TEXAS COMMISSION ON ENVIRONMENTAL QUALITY

Re: Edwards Aquifer, Comal County
NAME OF PROJECT: Mystic Bluff Residential Subdivision; Located 1300' south of the intersection of Cranes Mill Road and FM 306.; Comal County, Texas
TYPE OF PLAN: Request for Approval of a Contributing Zone Plan (CZP); 30 Texas Administrative Code (TAC) Chapter 213 Subchapter B Edwards Aquifer;
Edwards Aquifer Protection Program ID No. 2678.00; Investigation No. 567974; Regulated Entity No. RN105248058

RE: Mystic Bluff Residential Subdivision; Comal County;
ID No. 2678.00; Investigation No. 567974, RN No. RN105248058;
Responses to CZP Technical Review Comments

**STABILIZED
CONSTRUCTION EXIT
DETAIL**

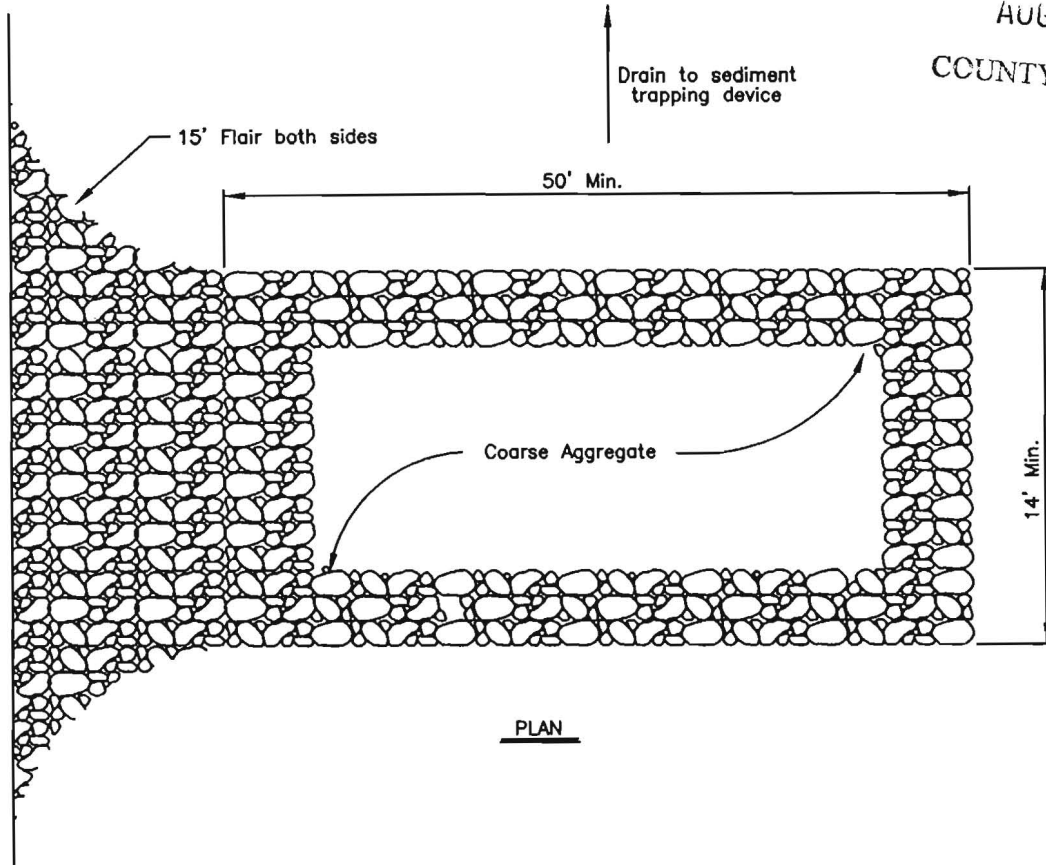
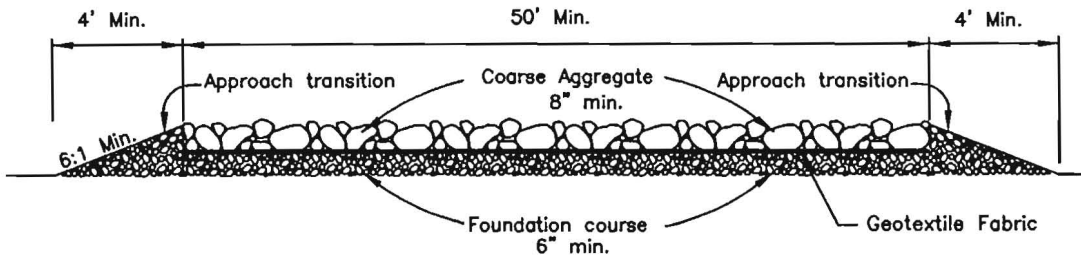
1. Comment: Include the CZP general construction notes on the site plan.
Response: The construction notes are now included on the site plan.
- 2.a). Comment: Add a flared entrance, 8" aggregate and geotextile fabric to the construction exit detail.

Response: The construction exit detail has been revised to show a 15' entrance flare, 8" min. depth of aggregate above the foundation course, and geotextile fabric below the coarse aggregate. A note has also been added specifying the type of geotextile fabric.

SILT FENCE DETAIL

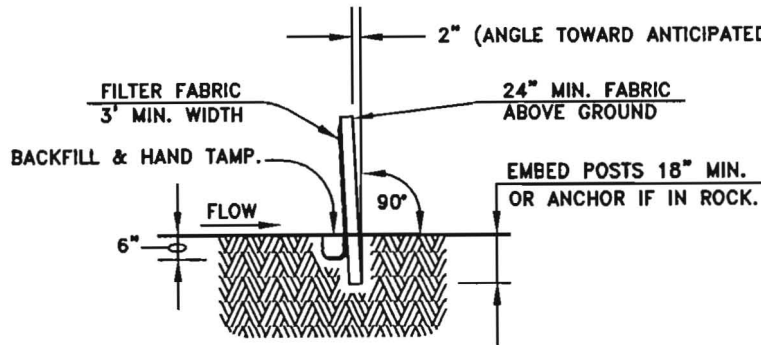
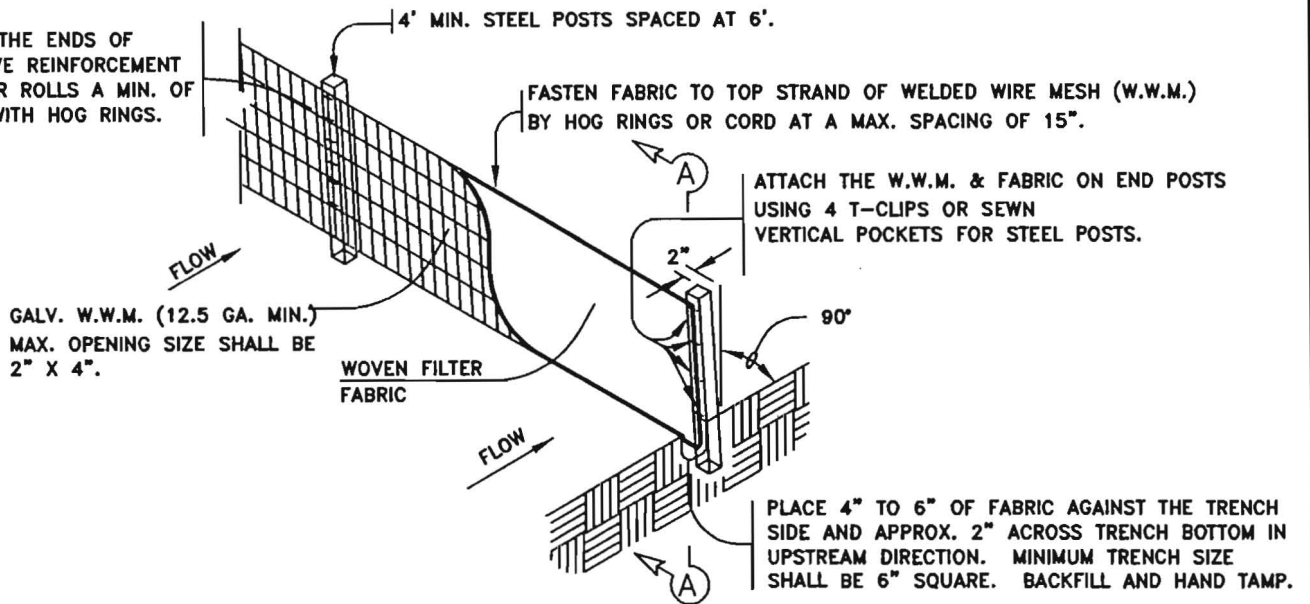
- 2.b). Comment: Revise the silt fence detail to spec. steel posts instead of wood with a slight angle toward the runoff direction.
Response: The detail has been revised to spec. steel posts only. A note has been added to Section A-A requiring a slight angle toward the runoff direction.
